## STP MSPI FAQ – Estimates

#### Millstone MSPI FAQs:

Figure 1

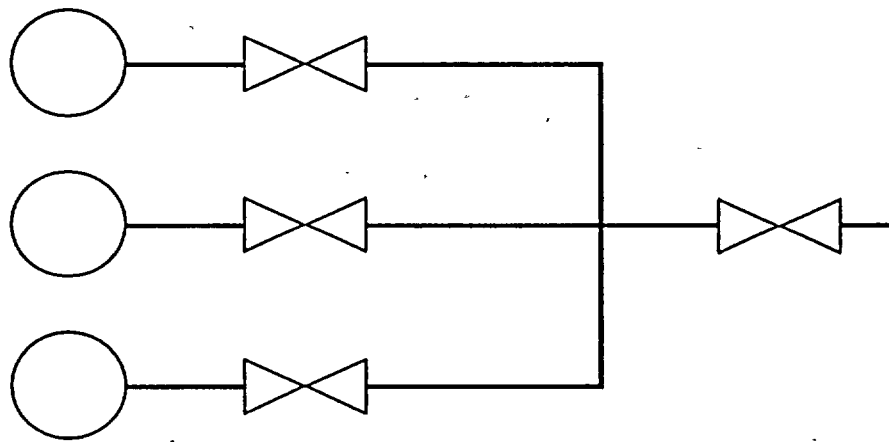
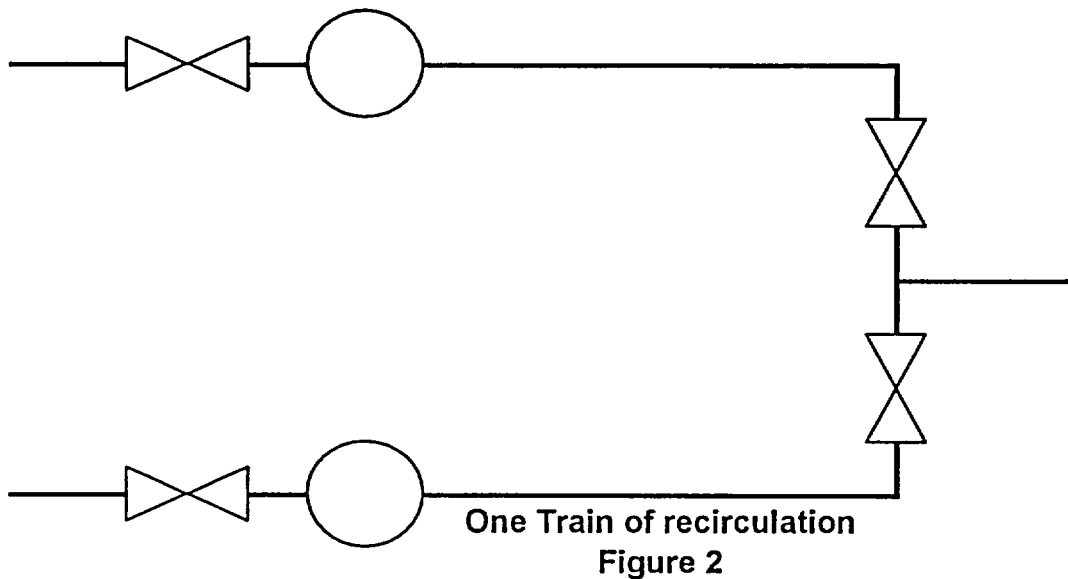
- a) MP3 has three charging pumps. Each pump has one MOV on its recirculation line. There is an additional MOV on the common line (Figure 1). The three branch lines are power off one train and the common line is powered off the opposite train. Therefore for each pump either the common MOV or the branch line MOV must go closed. If the branch line MOVs and the common MOV do not close, all trains are lost. Would these valves be considered active?

*what are system  
screen criteria*

The charging minimum recirculation valves would be counted as active valves since they do not meet the redundancy criteria in that a failure of all valves impacts both trains. *The NRC staff concurs that this configuration is not a clear case of the straightforward parallel/series configuration discussed in Appendix F. As a first step, the valves in question here should be screened-in and included in the MSPI program. However, guidelines for excluding certain active valves based on low risk significance are being considered. If the FV/UR for any or all of these valves is lower than 0.1, and there is an overly burdensome number of valves that would otherwise be monitored (e.g. 20 or more total valves), then there is a justifiable basis for excluding some or all of these valves. The licensee should assess the FV/UR for these valves against the 0.1 FV/UR criterion, and consider alternatives.*

Figure 3

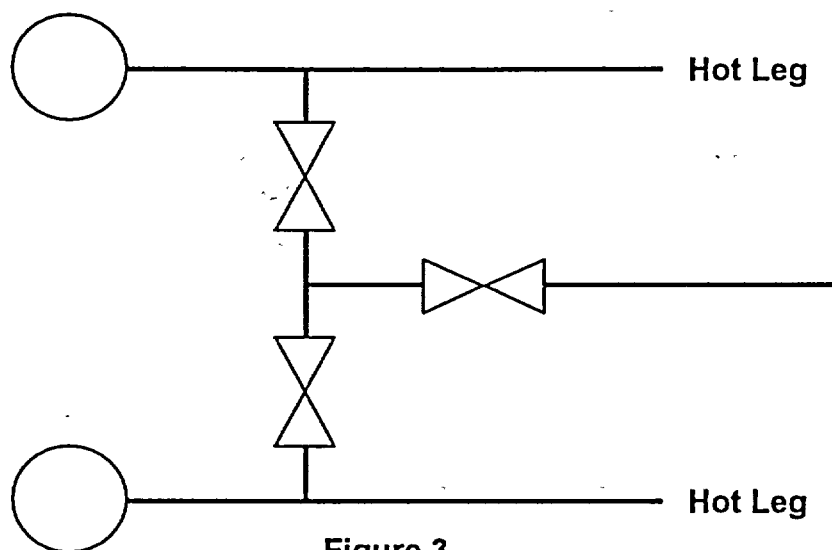
- c) At MP3 there are two trains for hot leg injection. Each train has a MOV in its discharge line to the cold legs and there is also a MOV in the common line to the cold legs. During switchover to hot leg injection, the discharge MOV to the cold legs is closed and the hot leg injection MOV is opened for one train and then the other train and then the common cold leg MOV is closed. To meet the hot leg injection requirements either the two discharge MOVs or the common cold leg MOV need to be closed. Would these valves be considered active?

Yes since if both the discharge MOVs or the common line MOV did not close both trains of hot leg injection would be lost. *The NRC staff concurs. The third bullet on page F-9 of NEI 99-02 may provide some additional guidance for this configuration, depending on the power sources for the valves in question. However, as with the case discussed in Question 5a above, the licensee could assess alternatives based on the FV/UR criterion for the valves in question here.*
